Energy to Serve Your World™
NL-03-0815

April 11, 2003

Joseph M. Farley Nuclear Plant
Responses to NRC Questions on
Relaxation Request to Order EA-03-009

**SNC Response to NRC Questions on
Relaxation Request to Order EA-03-009 Item IV.C.(1)(b)(i)**

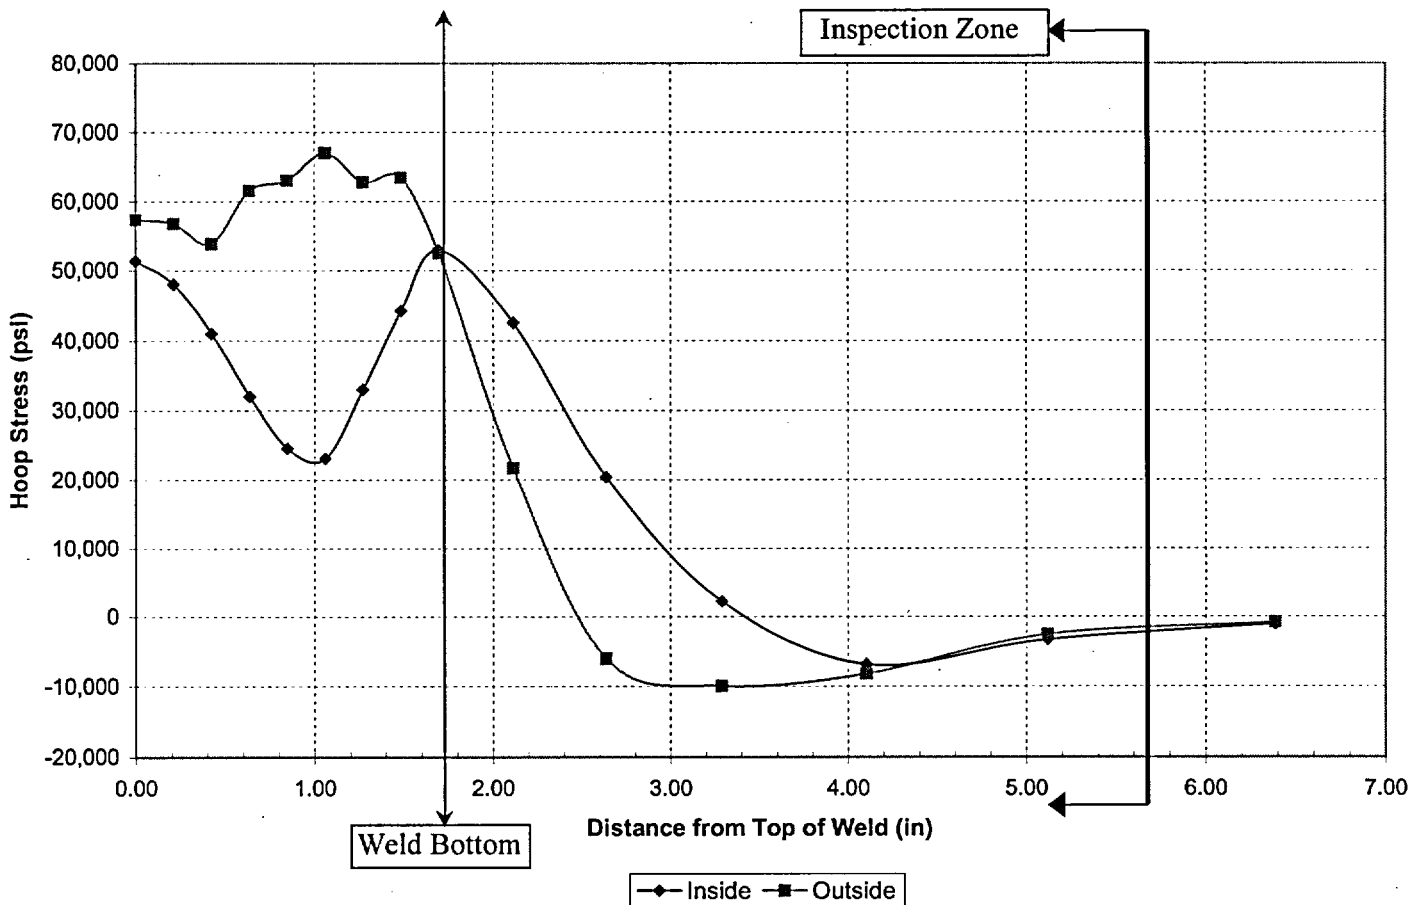
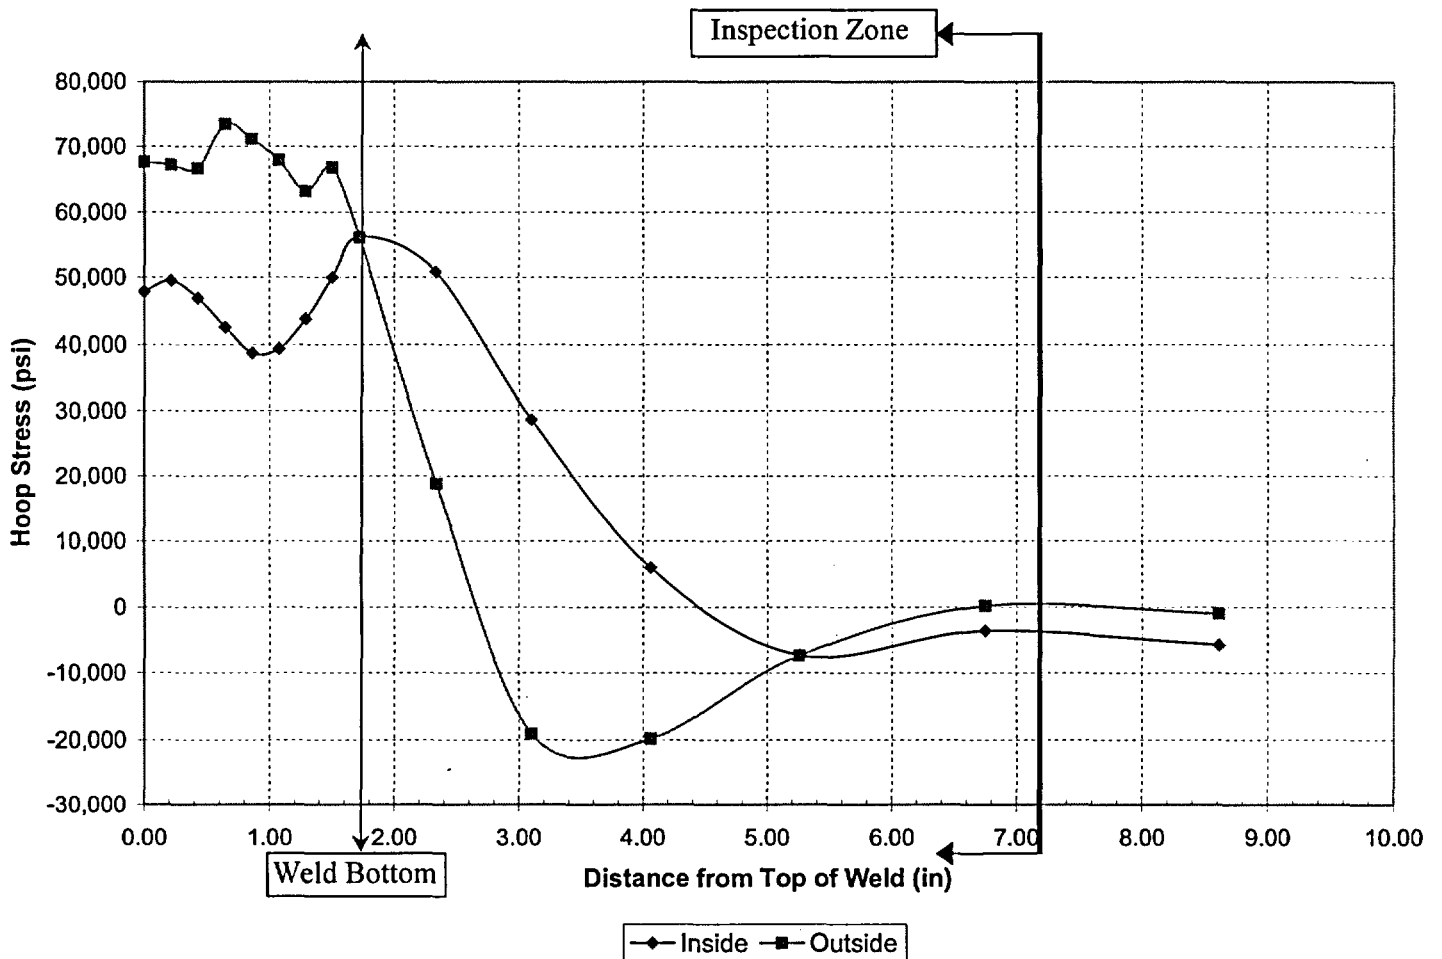
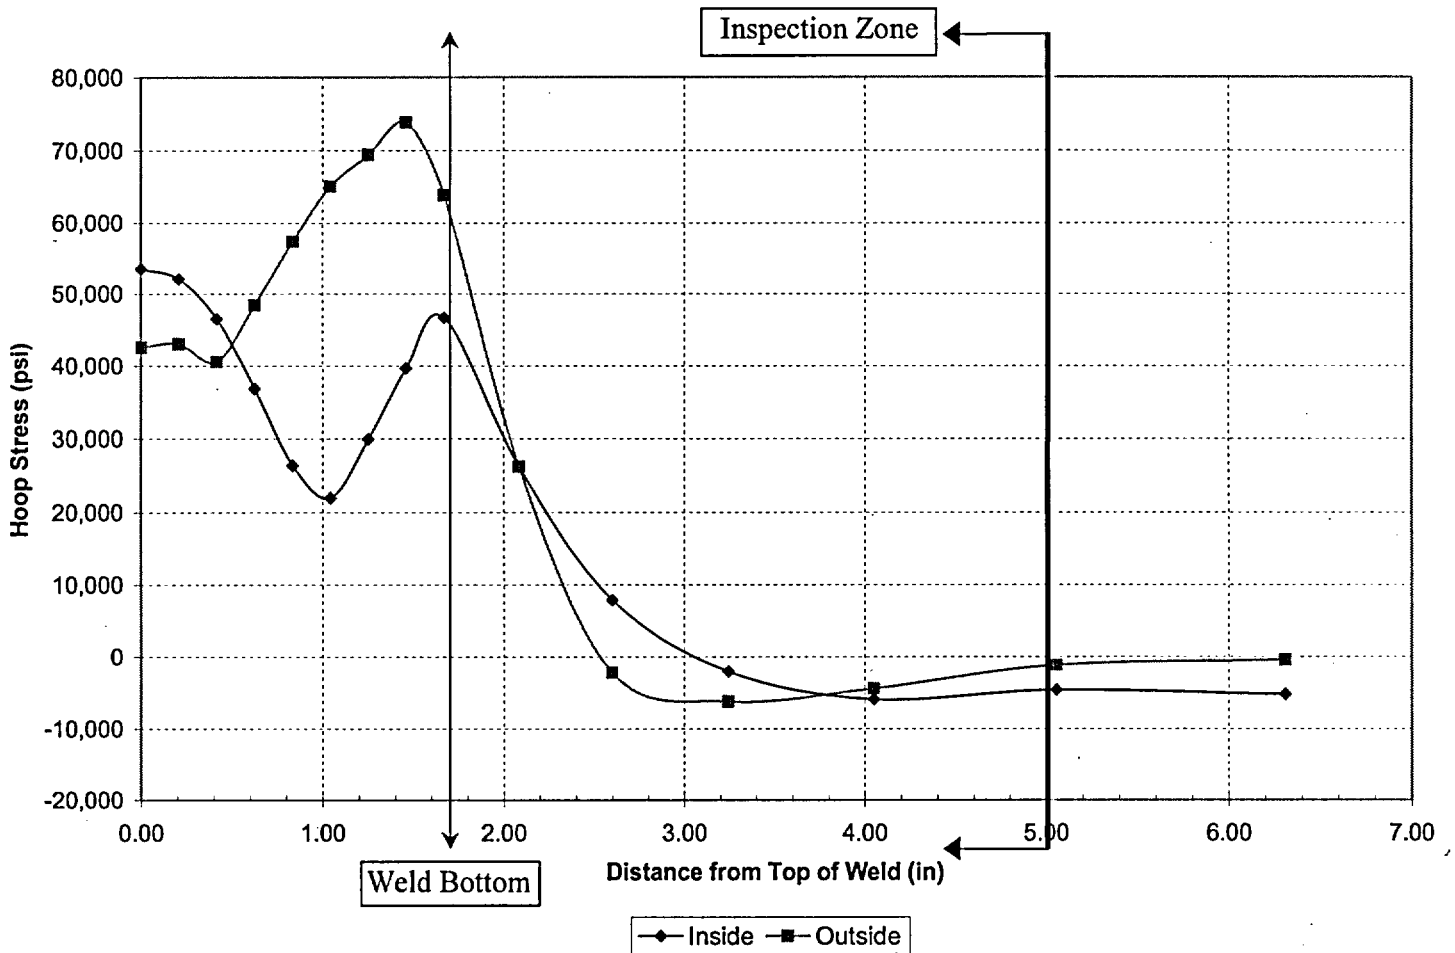
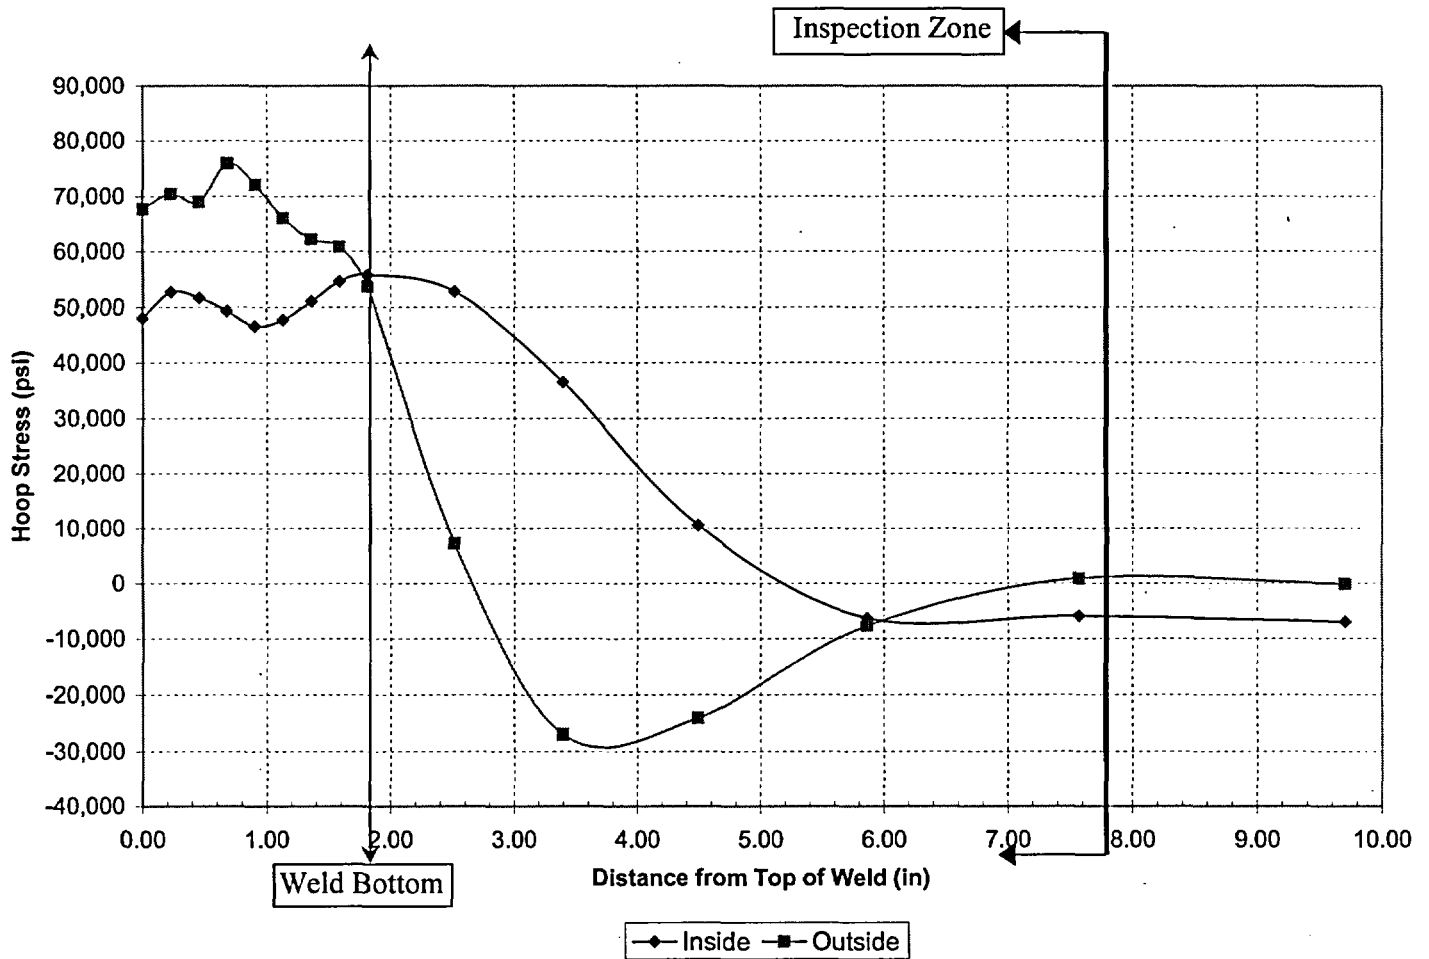
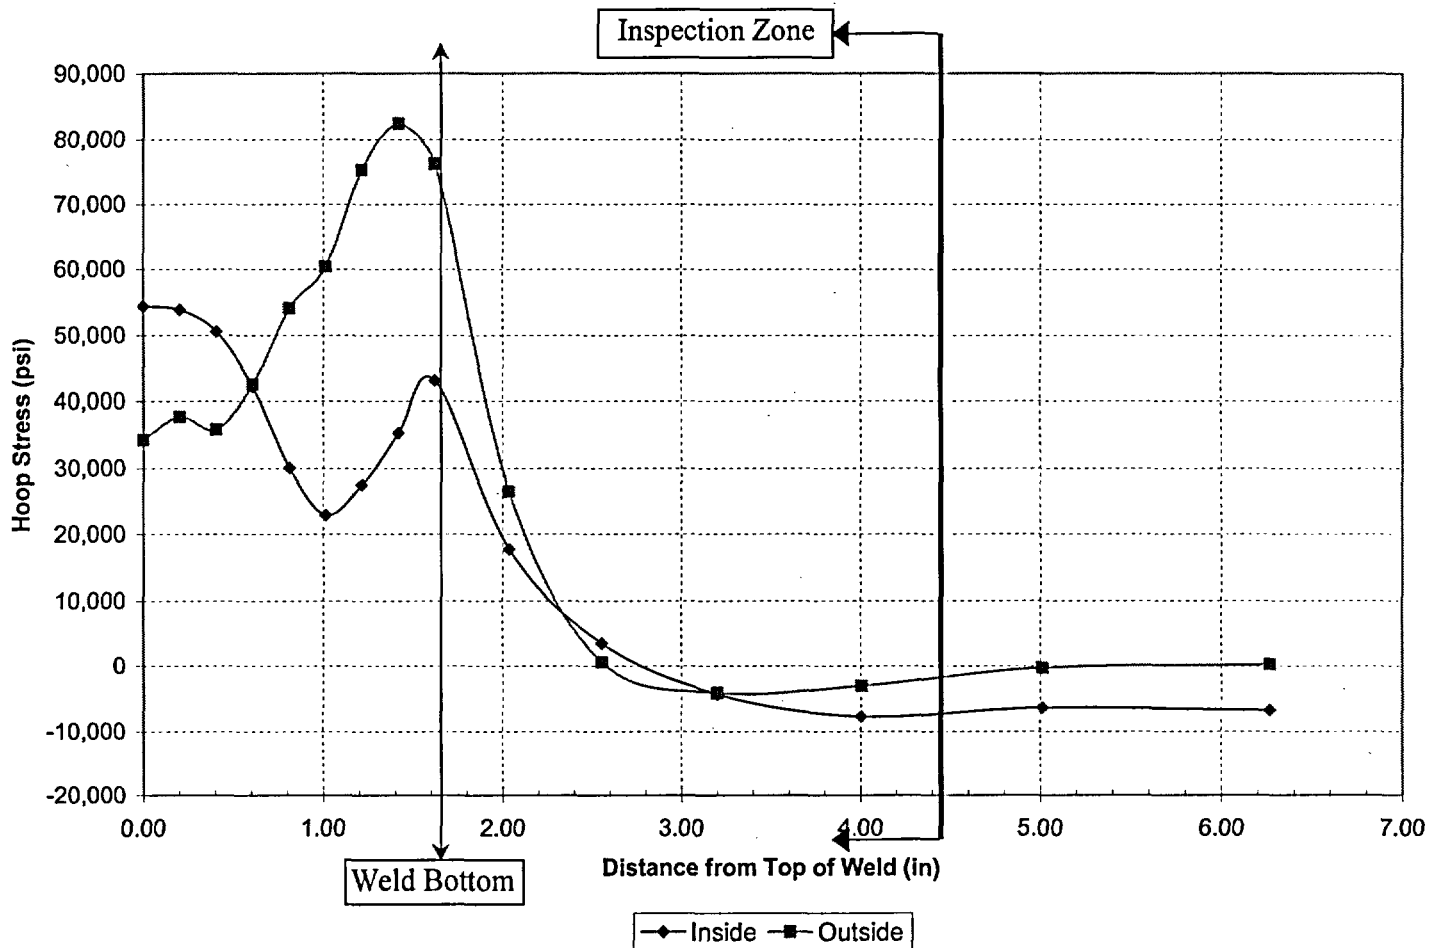
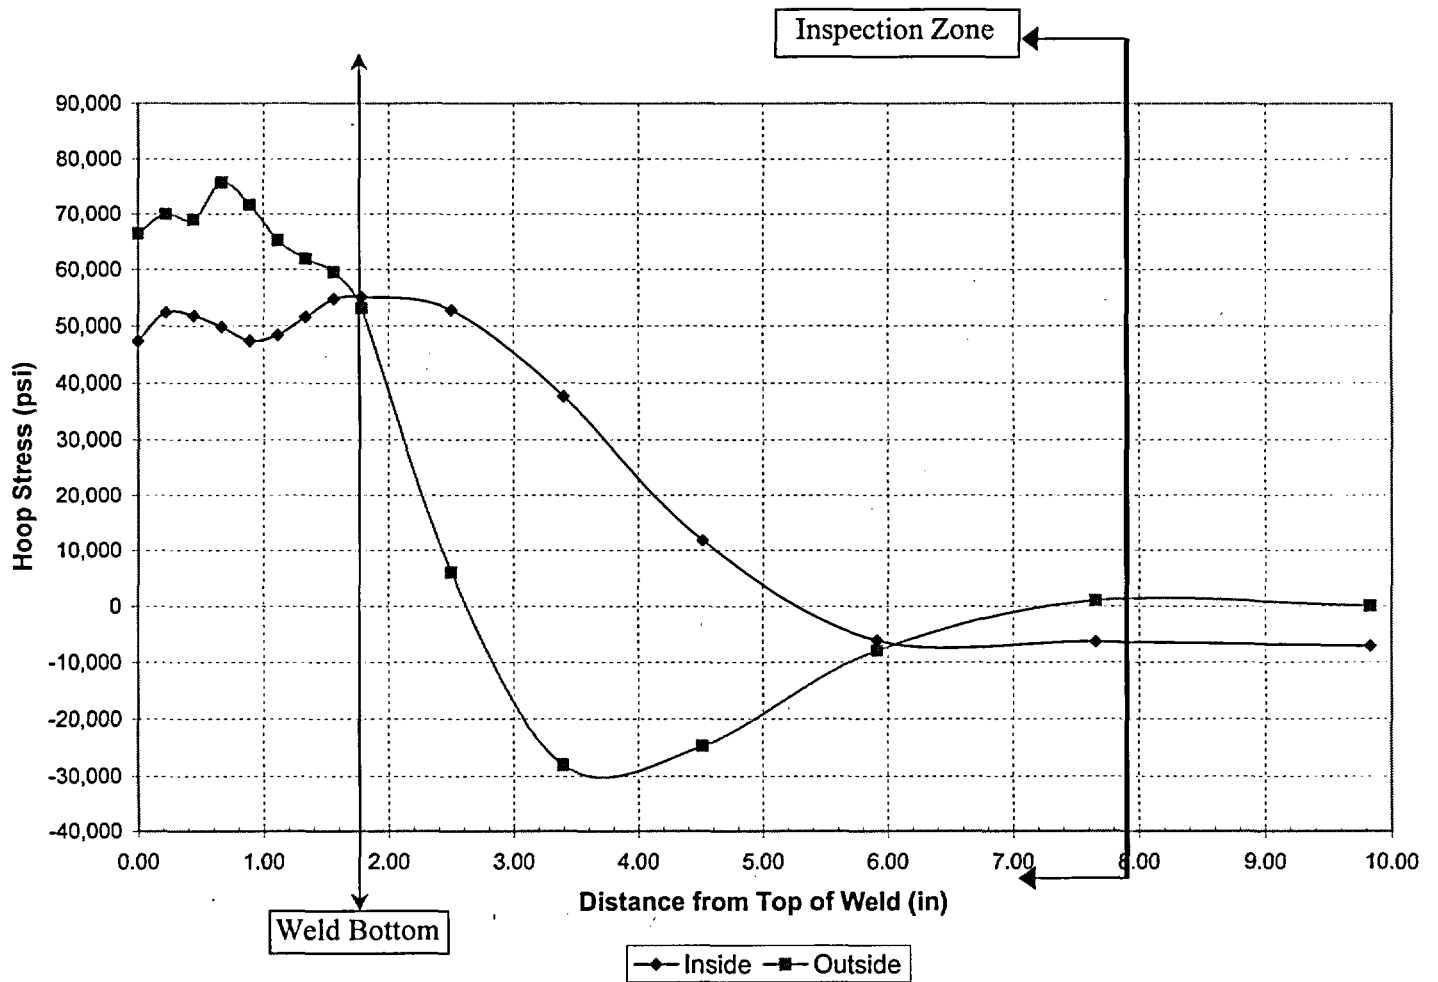
2. In your letter dated March 3, 2003, you stated that "UT of the most highly stressed portion of the nozzle is unaffected by this limitation." Please provide the stress profiles from the stress analysis in the J-groove weld region (across the cross-section) from the top of the J-groove weld to areas below the weld.

The hoop stress distributions, as a function of distance from the top of the weld for a range of penetration nozzle locations from the center of the RPV head to the outermost row, are provided in Figures 1 to 9. These stress profiles represent an alternate presentation of results from the analysis performed by Westinghouse for both FNP units as part of WCAP-15925-P, "Structural Integrity Evaluation of Reactor Vessel Upper Head Penetrations to Support Continued Operation: Farley Units 1 and 2." The expected zone of inspection coverage is also identified in each Figure. As shown in Figures 1 to 9, the magnitude of the stresses in the unexamined portion of the nozzles is low. The end data point is based on the stress model and not the physical end of the penetration tube.
